An Evaluation of the Status of Diablo Canyon Unit 1 With Respect to Reactor Pressure Vessel Condition Monitoring and Prediction

Part 1: Addressing Public Concerns

Consultant's report to the Diablo Canyon Independent Safety Committee

Date: 26 January 2024

Figure 19. Comparison of the EoE and T_{41J} transition temperature metrics estimated from Charpy data (left and right graph, respectively) to the fracture toughness transition temperature T_0 , estimated by ASTM Standard E1921 (vertical axis on both graphs). Data from [EricksonKirk 2009].

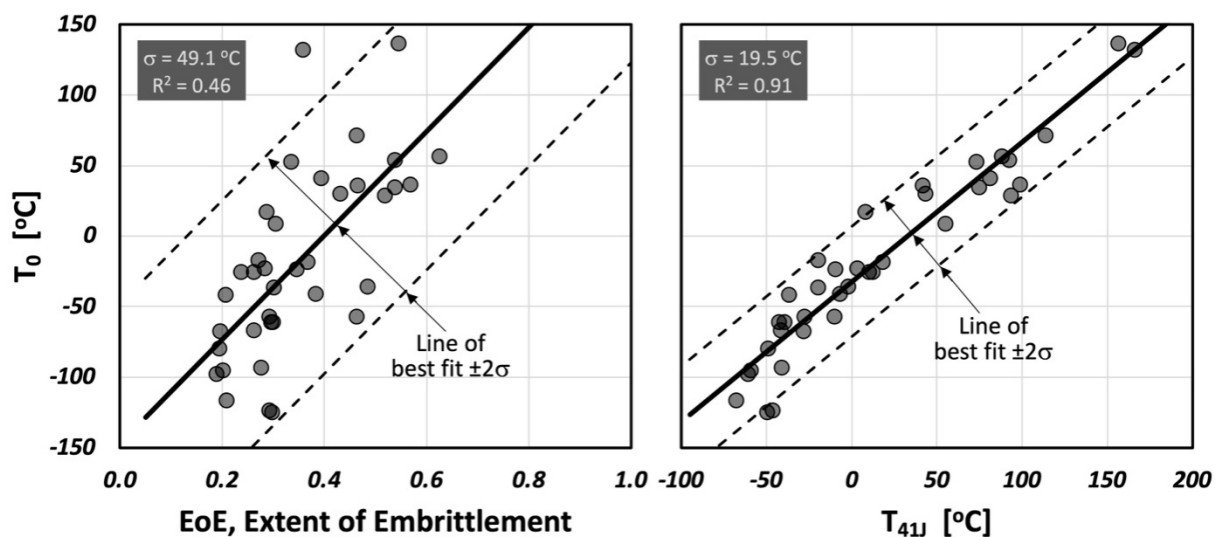
The Extent of Embrittlement (EoE) metric defined in [SLOMFP-NRC 2023] is a new transition temperature metric; it has not been previously discussed or reviewed in the professional literature. Since the Charpy test does not provide a direct quantification of fracture toughness, any metric determined from Charpy test data (T_{41J} , EoE, ...) can only be correlated to the fracture toughness transition temperature. In the 1970s when T_{41J} was adopted by the nuclear industry no testing standards existed to estimate the fracture toughness transition temperature, so the selection of T_{41J} over other metrics had to be based on judgement and limited data. The first edition of Regulatory Guide 1.99 [RG1.99R0] published in 1975 states explicitly “it has been assumed herein that the adjustment of the reference temperature [for fracture toughness] is equal to the 30 foot-pound shift [in Charpy energy].” However, since 1997 an ASTM testing standard has been available to quantify the transition temperature of fracture toughness data, which as discussed in Chapter 2 is called T_0 [ASTM E1921]. Figure 19 compares the EoE and T_{41J} Charpy metrics to values of the fracture toughness transition temperature T_0 based on data

for a variety of RPV steels tested over a wide range of embrittlement reported in [EricksonKirk 2009]. This comparison shows that EoE is not as well correlated with the fracture toughness transition temperature, T_0 , as is T_{41J} . Also, if EoE were used to predict T_0 the uncertainty in that prediction would be 2½-times greater than the uncertainty associated with a prediction of T_0

from T_{41J} (compare a standard deviation (σ) value of 49.1 °C for EoE with a σ value of 19.5 °C for ΔT_{41J} , as noted in the legends of Figure 19). Thus, it appears appropriate to continue with the use of T_{41J} for embrittlement trending and structural integrity analyses of nuclear RPVs.

Figure 20. Figure 7 from [SLOMFP-NRC 2023].

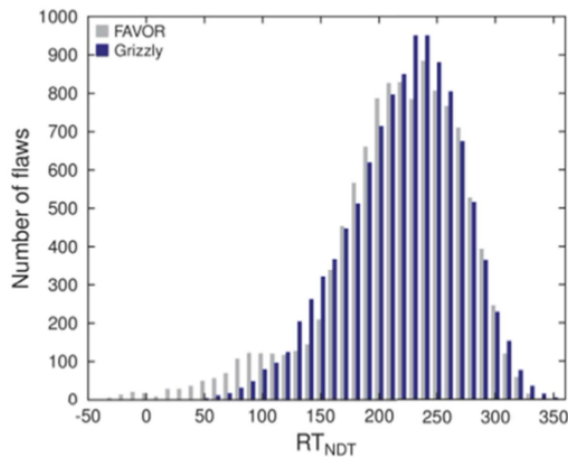
2. Spencer and coworkers at INL have modeled RPV embrittlement within the Grizzly and FAVOR [Fracture Analysis of Vessels] codes [Spencer et.al. (2015, 2016)]. These are computer algorithms that were developed at Idaho National Laboratory (INL) and Oak Ridge National Laboratory (ORNL), respectively, for modeling the embrittlement and physical changes to RPVs under neutron irradiation. Typical distributions of the number of flaws in a RPV with respect to RT_{NDT} as predicted by FAVOR and Grizzly are shown in Figure 7. FAVOR, which was developed at the ORNL, is acknowledged as providing an accurate prediction of the number and distribution of flaws in a PWR RPV and Grizzly are found to be in excellent agreement except for at the tail for $RT_{NDT} < 120$ °F. Accordingly, it is difficult to accept and understand PG&E's claim of detecting only one indication in the 2005 UT examination of beltline materials at Diablo-Canyon, Unit 1,

when Figure 7 indicates thousands as determined by summing the number of indications for each bar. ([SLOMFP-NRC 2023], pdf page 65).

Figure 21. Figure 10 from [SLOMFP-NRC 2023].

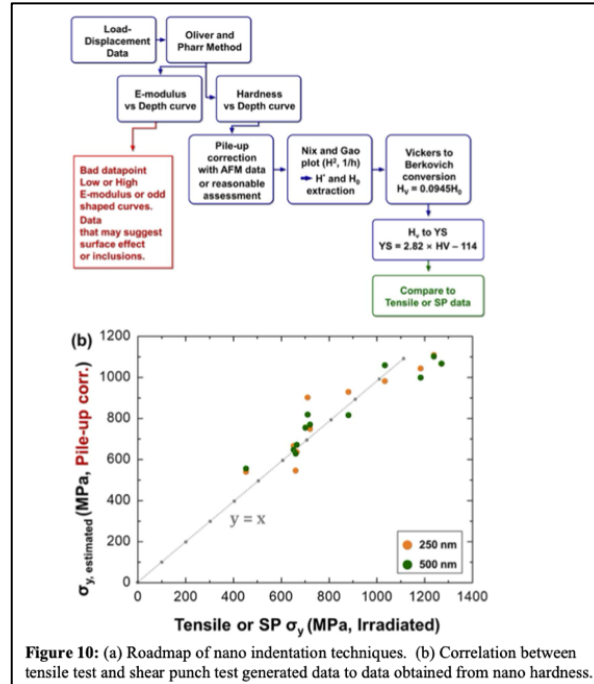
3. Professor Peter Hosemann, the developer of the nano indentation method at UC Berkeley and my fellow faculty in the Department of Nuclear Engineering kindly contributed the following material that describes the method in greater depth than my account given above and outlines some of his work on using it to characterize the radiation embrittlement of RPV steels. Any additions/clarifications other than correcting grammatical errors, such as missing articles, etc. that I have made to Prof. Hosemann's account are identified in italics. ([SLOMFP-NRC 2023], pdf page 70).

4. In recent years, scientists have spent significant effort to correlate and calculate more relevant engineering data from simple nano hardness measurements and utilize the benefits of large data numbers from indentation experiments. Several approaches emerged from these efforts allowing one to quantify yield strength as a function of irradiation conditions. Figure 10 (Figure 10 from [SLOMFP-NRC 2023] appears here as Figure 21) shows one approach originally developed by Hosemann et al. and adopted and modified by Zinkle and others. In this approach, the nano-hardness is used to calculate a macro-hardness (corrected for pile up) which then in turn is used to calculate yield strength [Figure 10 (a)]. A blind test conducted over different reactor irradiated materials compares tensile test and shear punch test generated data to data obtained from nano-hardness. As one can see there is a clear agreement between these very different measurements [Figure 10 (b)] again with the benefit that no elaborate sample preparation is needed while always collecting more than 15 datapoints per sample. Therefore, each datapoint is an average of 15 measured datapoints. The large number of datapoints allows the distribution function to be determined and the appropriate error to be specified (e.g., the standard deviation) with an accuracy that is not possible using Charpy analysis. ([SLOMFP-NRC 2023], pdf page 71).
